TECHNICAL BULLETIN
[1 / 4]

[Issue No.] FA-A-0204

[Title] Announcement for the changes of prints on the communication LSI for CC-Link Family compatible products development

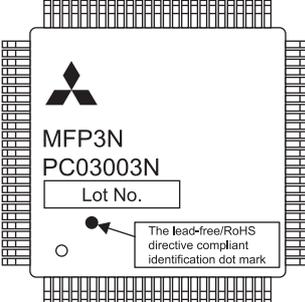
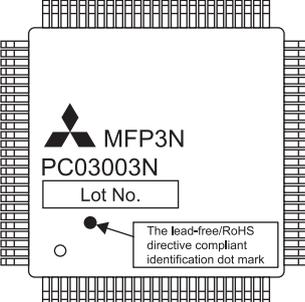
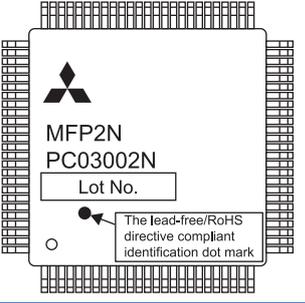
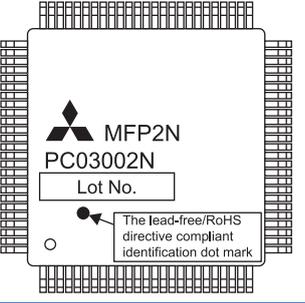
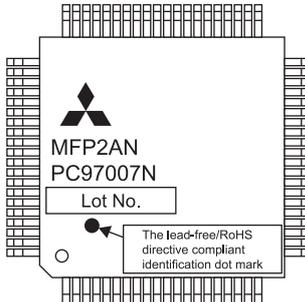
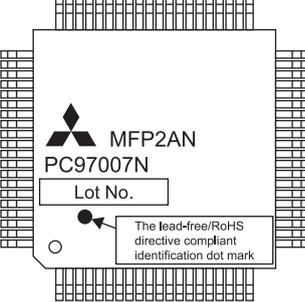
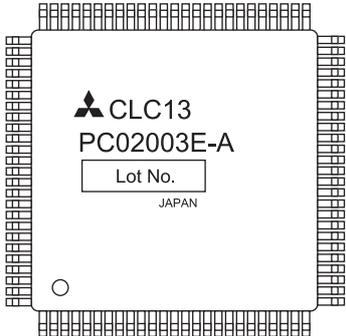
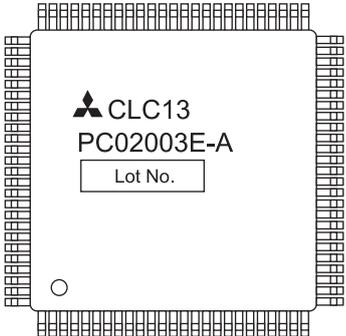
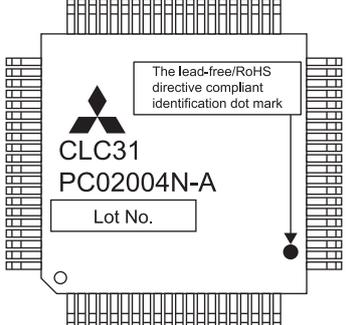
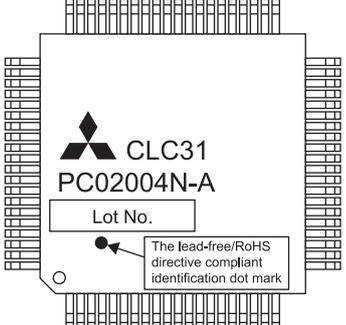
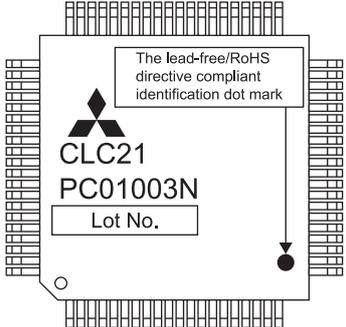
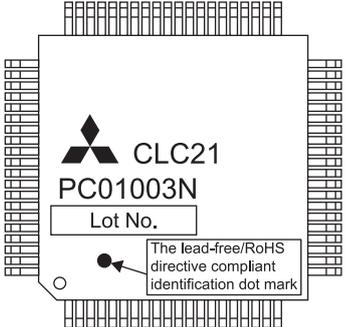
Contents and basic layouts of the prints on the products are changed to standardize as follows.

Product	Before change	After change
CP220	 <p>MITSUBISHI CP220 PC08004N Lot No. The lead-free/RoHS directive compliant identification dot mark</p>	 <p> CP220 PC08004N Lot No. The lead-free/RoHS directive compliant identification dot mark</p>
MFP3N	 <p> MFP3N PC03003N Lot No. The lead-free/RoHS directive compliant identification dot mark</p>	 <p> MFP3N PC03003N Lot No. The lead-free/RoHS directive compliant identification dot mark</p>
MFP2N	 <p> MFP2N PC03002N Lot No. The lead-free/RoHS directive compliant identification dot mark</p>	 <p> MFP2N PC03002N Lot No. The lead-free/RoHS directive compliant identification dot mark</p>
MFP2AN	 <p> MFP2AN PC97007N Lot No. The lead-free/RoHS directive compliant identification dot mark</p>	 <p> MFP2AN PC97007N Lot No. The lead-free/RoHS directive compliant identification dot mark</p>

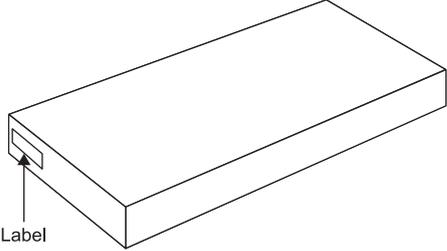
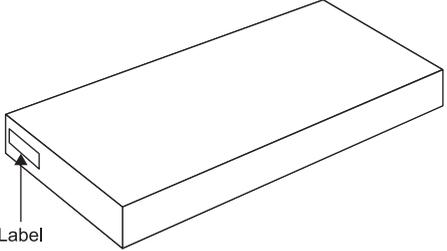
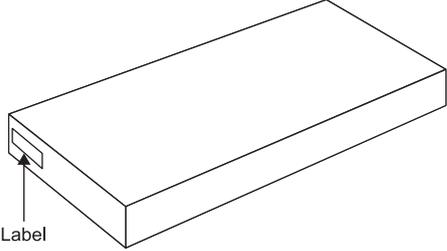
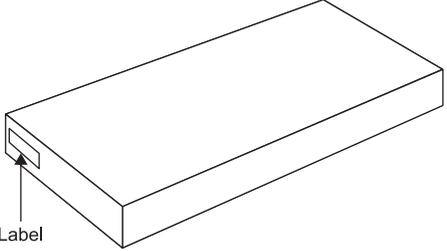
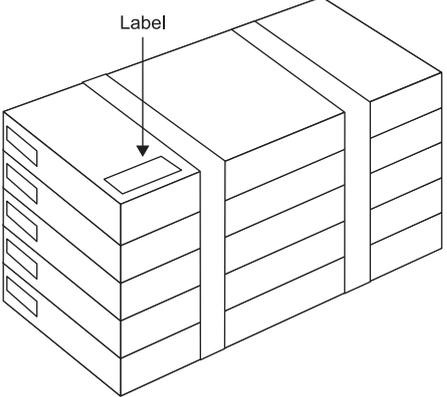
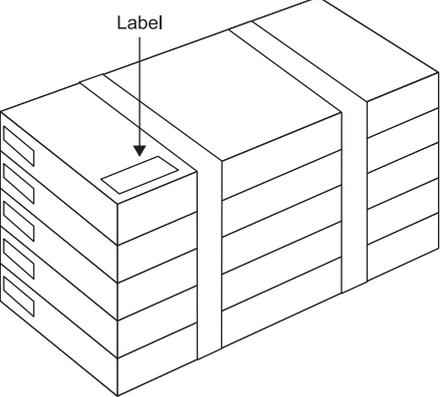
Product	Before change	After change
CLC13		
CLC31		
CLC21

(2) For the CLC31 and CLC21, whether before-change or after-change product can be recognized by the product name on the outer package.

Outer package		
Model (product)	Before change	After change
CL2GA31-60 (CLC31)	 <p>Label</p> <p>Product name on the label: PC02004N-A BKO-C11149 H02</p>	 <p>Label</p> <p>Product name on the label: PC02004N-A BKO-C11149 H04</p>
CL2GA21-60 (CLC21)	 <p>Label</p> <p>Product name on the label: PC01003N BKO-C11117 H02</p>	 <p>Label</p> <p>Product name on the label: PC01003N BKO-C11117 H05</p>
CL2GA21-300 (CLC21)	 <p>Label</p> <p>Product name on the label: PC01003N BKO-C11117 H03</p>	 <p>Label</p> <p>Product name on the label: PC01003N BKO-C11117 H06</p>
